HANNAH RIDGE AT FEATHERGRASS FILING NO. 7

A REPLAT OF TRACT LL OF HANNAH RIDGE AT FEATHERGRASS FILING NO. 1, RECEPTION NO. 214713468, RECORDS OF EL PASO COUNTY, COLORADO AND TRACT A AS PLATTED IN HANNAH RIDGE AT FEATHERGRASS FILING NO. 6, RECORDED UNDER RECEPTION NO. _____, SECTION 32, TOWNSHIP 13 SOUTH, RANGE 65 WEST OF THE SIXTH PRINCIPAL MERIDIAN, EL PASO COUNTY, COLORADO

HANNAH RIDGE AT FEATHERGRASS FILING NO. 7
JOB NO. 1116.07
OCTOBER 4, 2018
SHEET 1 OF 3
OWNER: FEATHERGRASS INVESTMENTS, LLC
4715 NORTH CHESTNUT STREET, SUITE 200
COLORADO SPRINGS, CO 80907

HANNAH RIDGE AT FEATHERGRASS
 FILING NO. 7
 JOB NO. 1116.07
 OCTOBER 4, 2018
 SHEET 2 OF 3

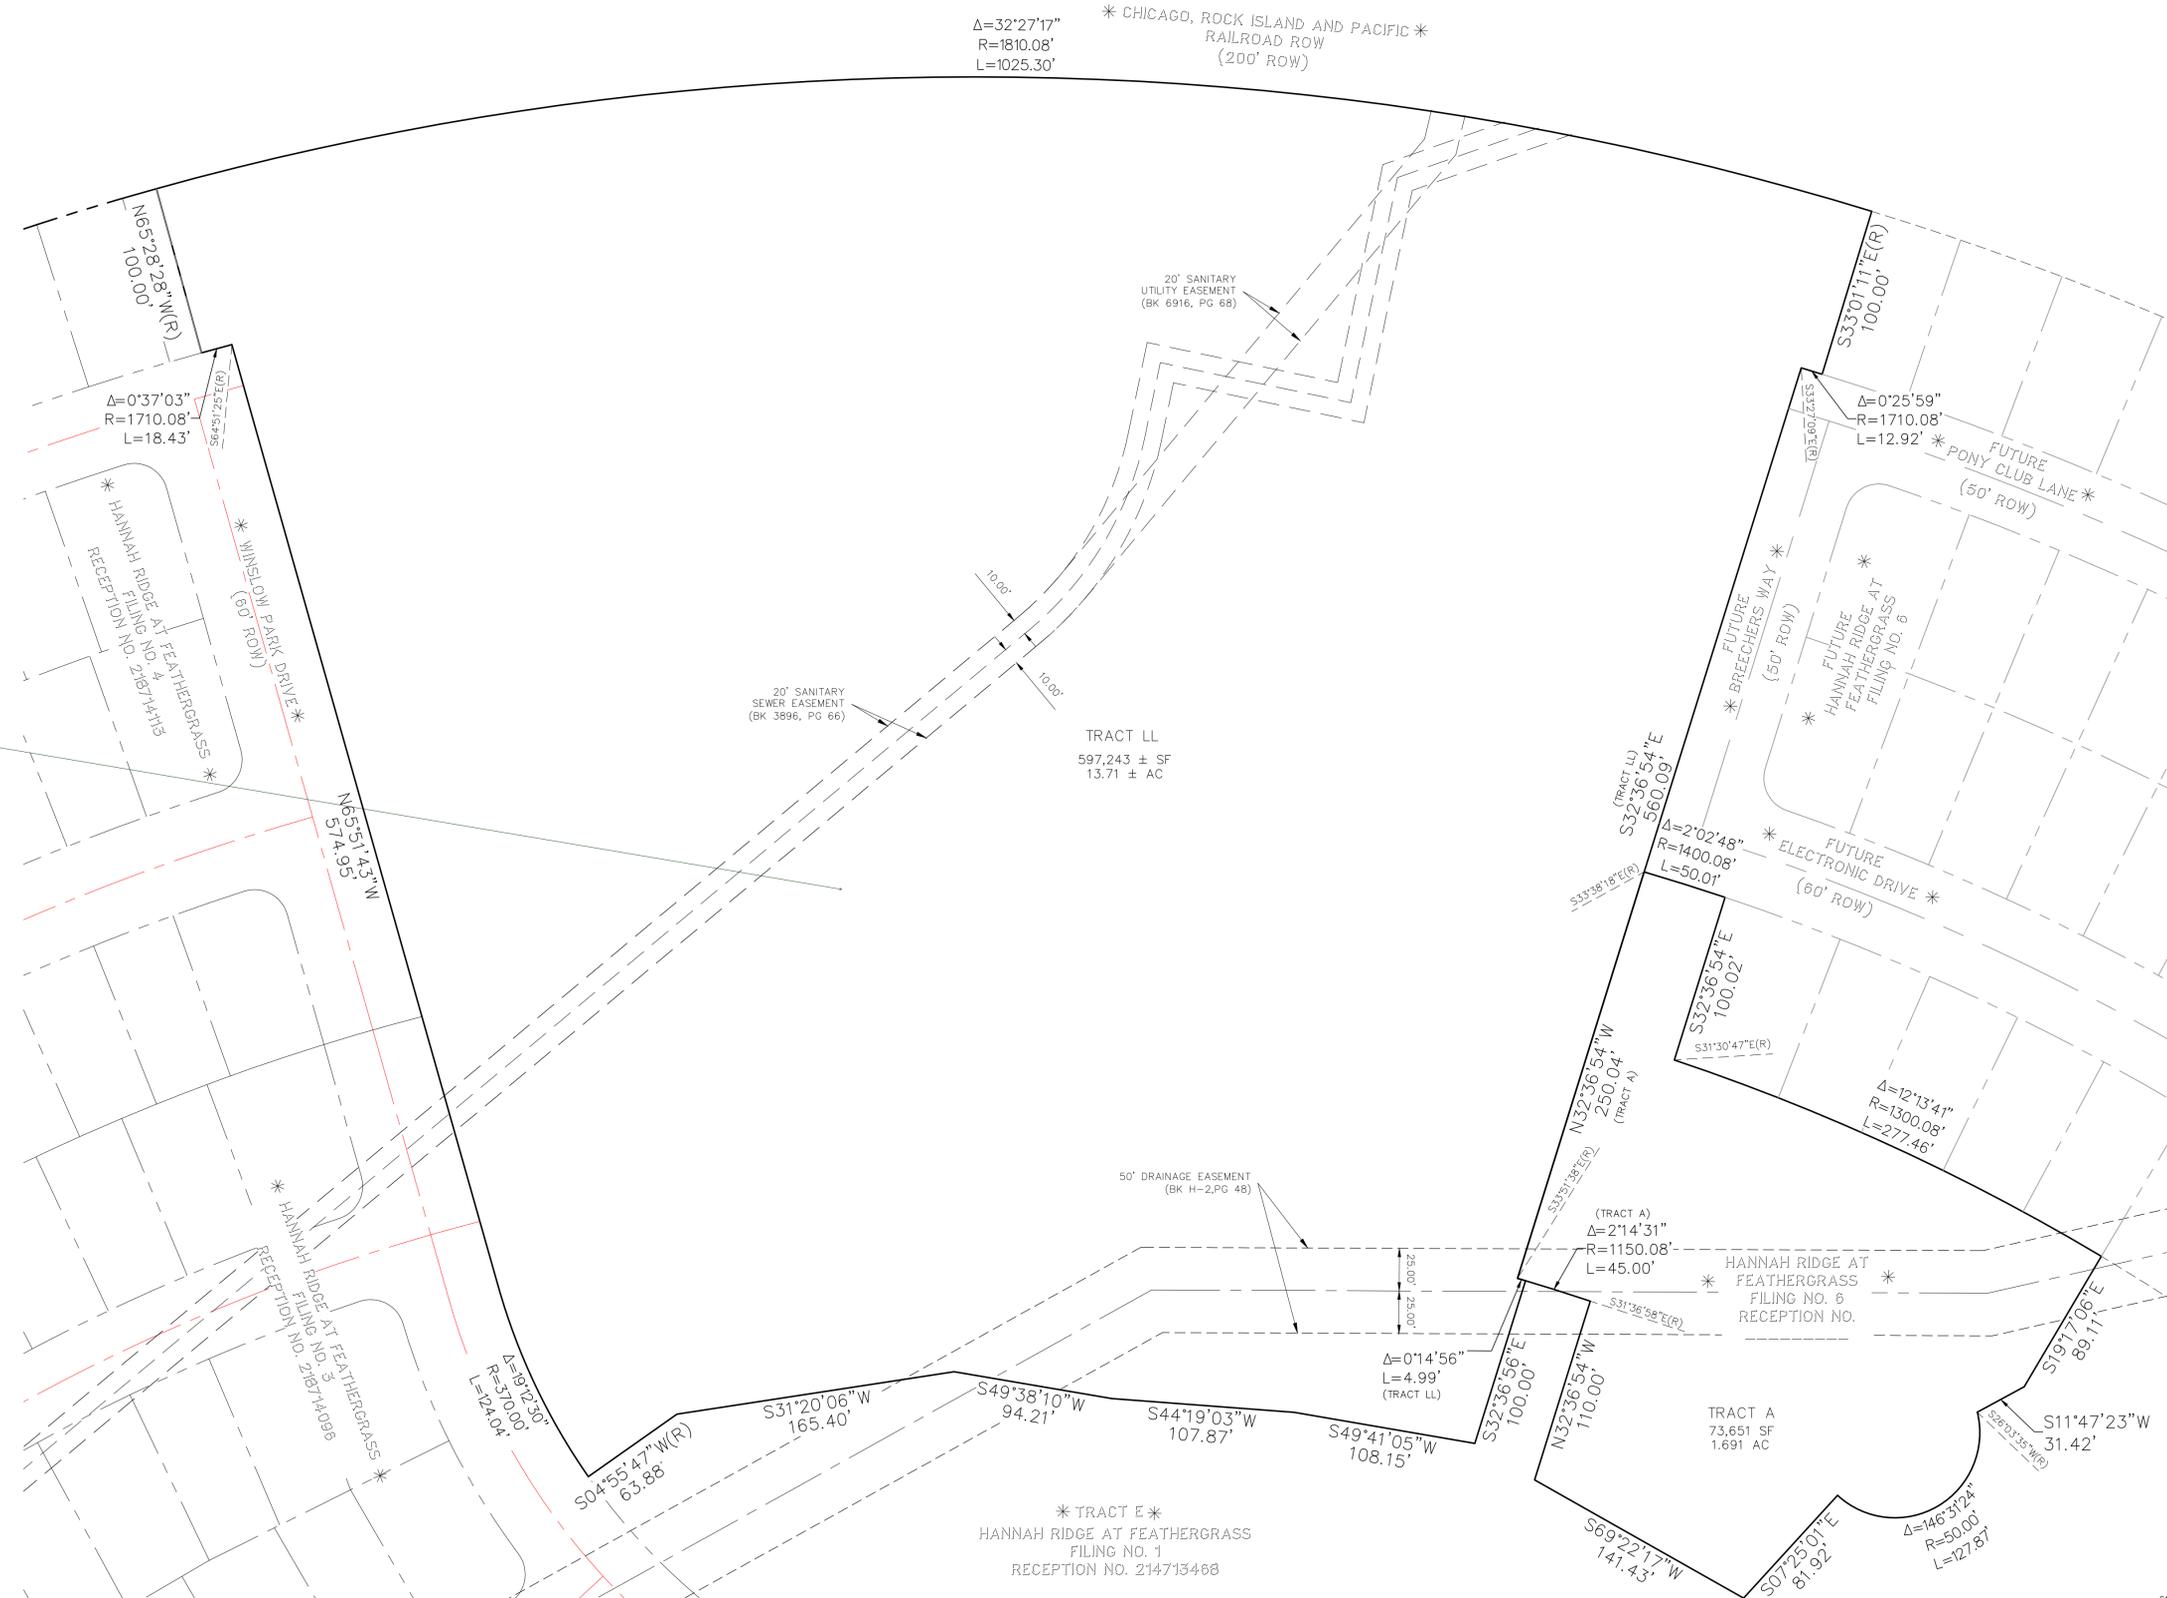
Where is the CIG
 easement? The title
 work identifies an
 easement. Is it going
 away?
 Please verify all
 encumbrances are
 shown and then
 identify if they are to
 be vacated

HANNAH RIDGE AT FEATHERGRASS
FILING NO. 7
JOB NO. 1116.07
OCTOBER 4, 2018
SHEET 3 OF 3

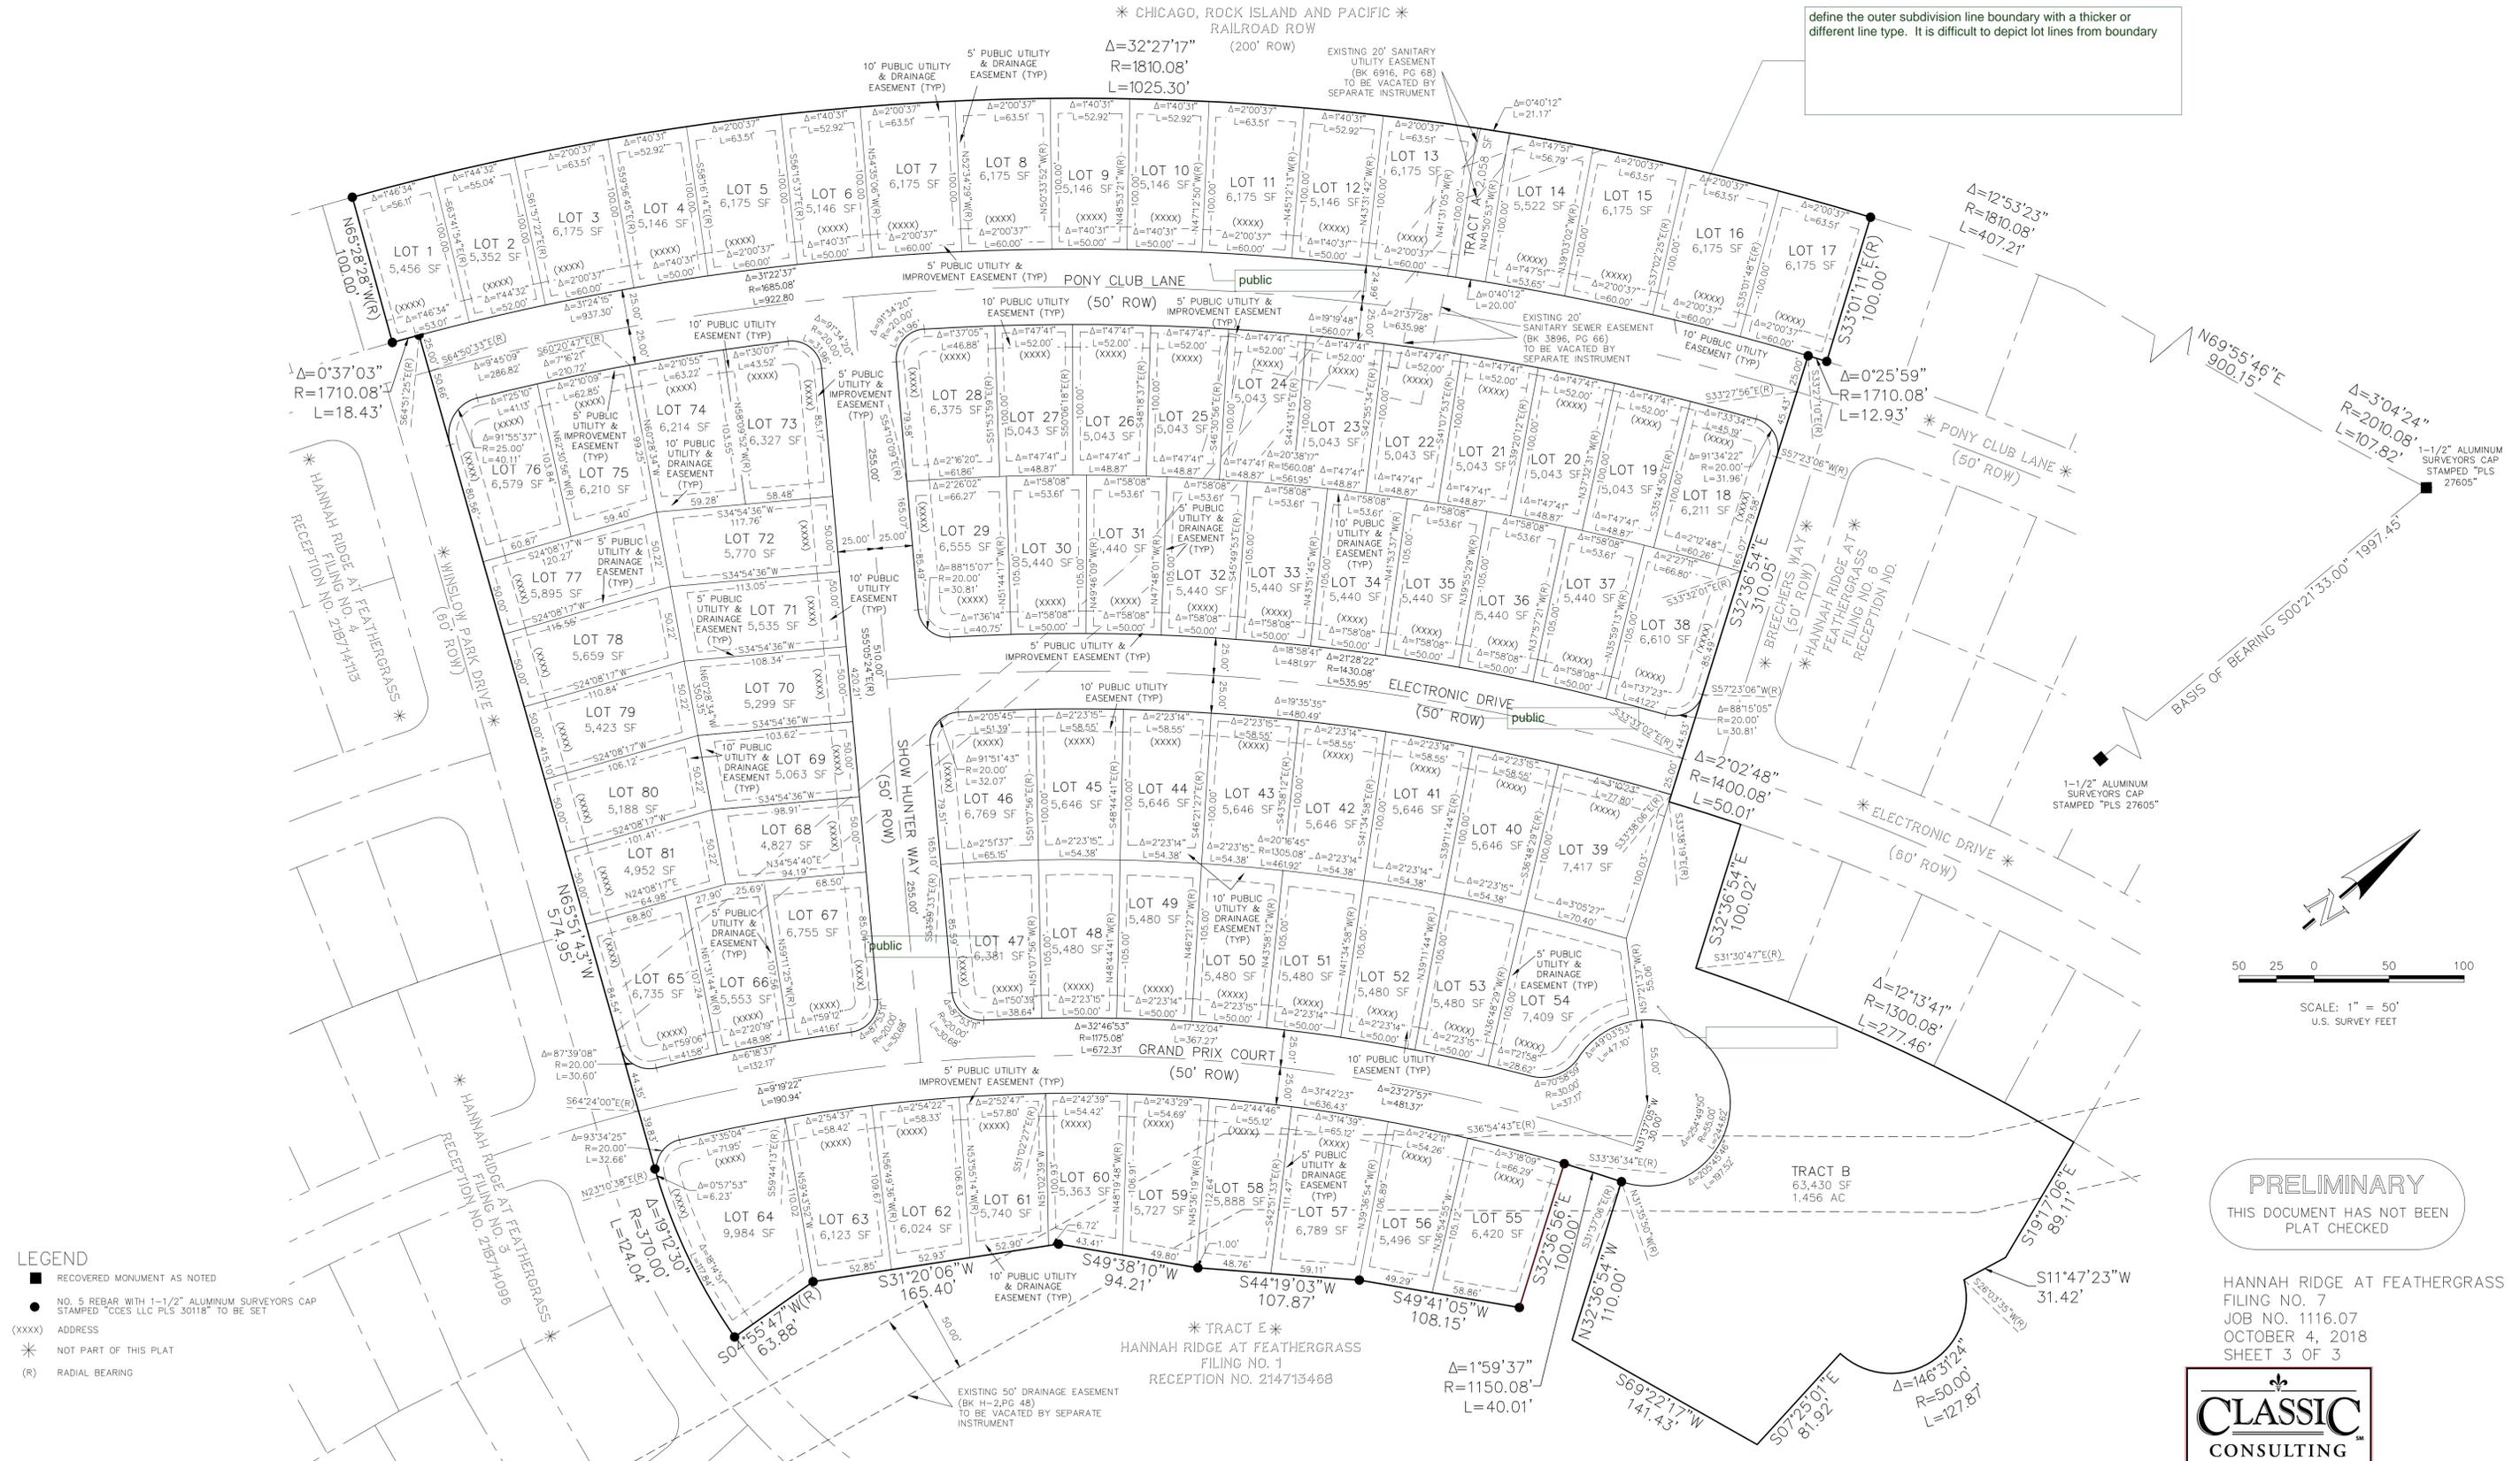
define the outer subdivision line boundary with a thicker or different line type. It is difficult to depict lot lines from boundary
